Appendix D – Landscape Design changes

College Of Fine Arts UNSW

Landscape Design Changes
February 2011
Site Image Landscape Architects

VII. Proposed landscape design changes, indicating areas C1, C2, C3

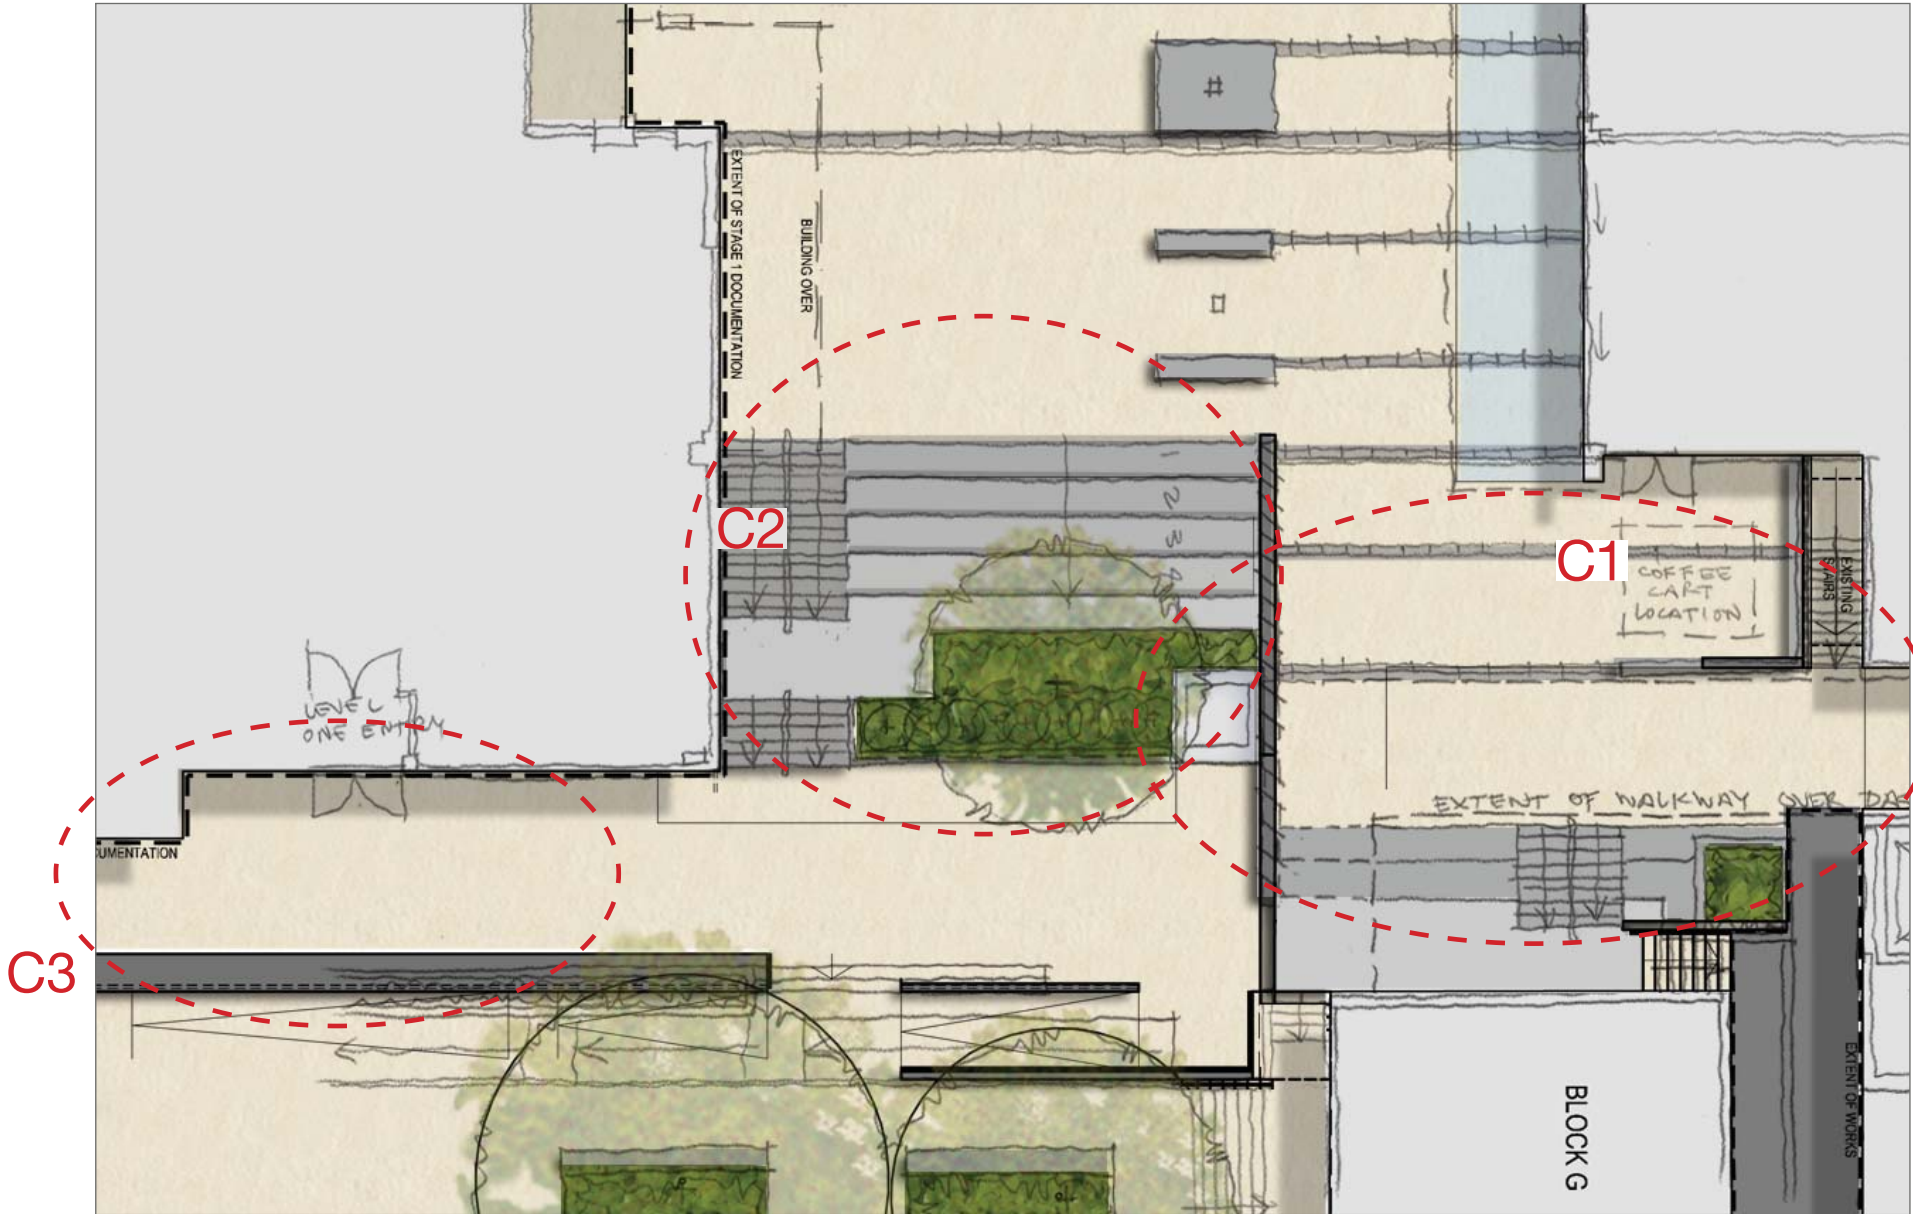
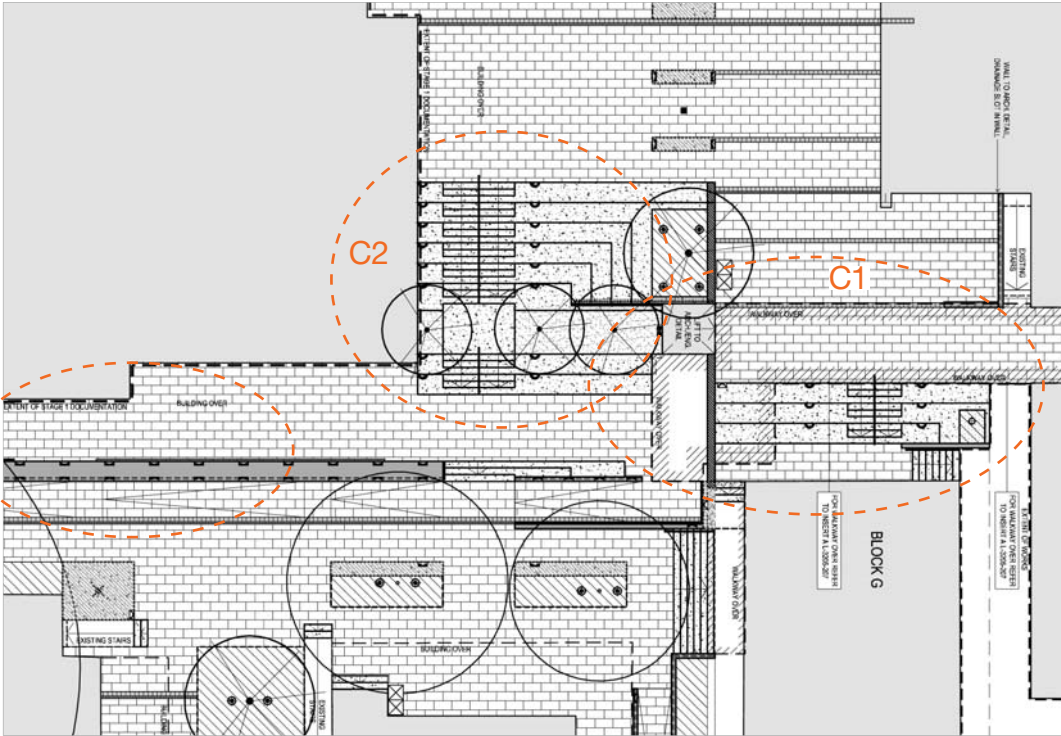
A range of changes have each had minor impact on the area, but together these result in a need for adjust to the seating benches / stairway design / alignment.

- elevator becomes a air vent to the carpark;
- the Level 1 bridge walkway adjusts to not not connect to the eliminated 'Lift';
- Building D has moved East and impacts on the stair / benches area

Minor adjustment required only to benches and steps to suit final design development of layout, levels and drainage.

New arrangement has general changes, but all retain the principal design function and general layout of the area.

- stairs moved to adjoin Building D (benches became too narrow);
- tree planter moved to avoid conflict with reinstated heritage wall
- benched seating no longer includes angled return towards the south, as a result of the narrowed general dimension being insufficient;
- the bench seating detailing will require refinement so that the adjoining heritage wall is retained as an independent element, with suitable contrasting expression of the end of the Bleachers above.

Overhead canopy removed as part of Architectural changes - affects the general amenity of the ramps / walkway link.
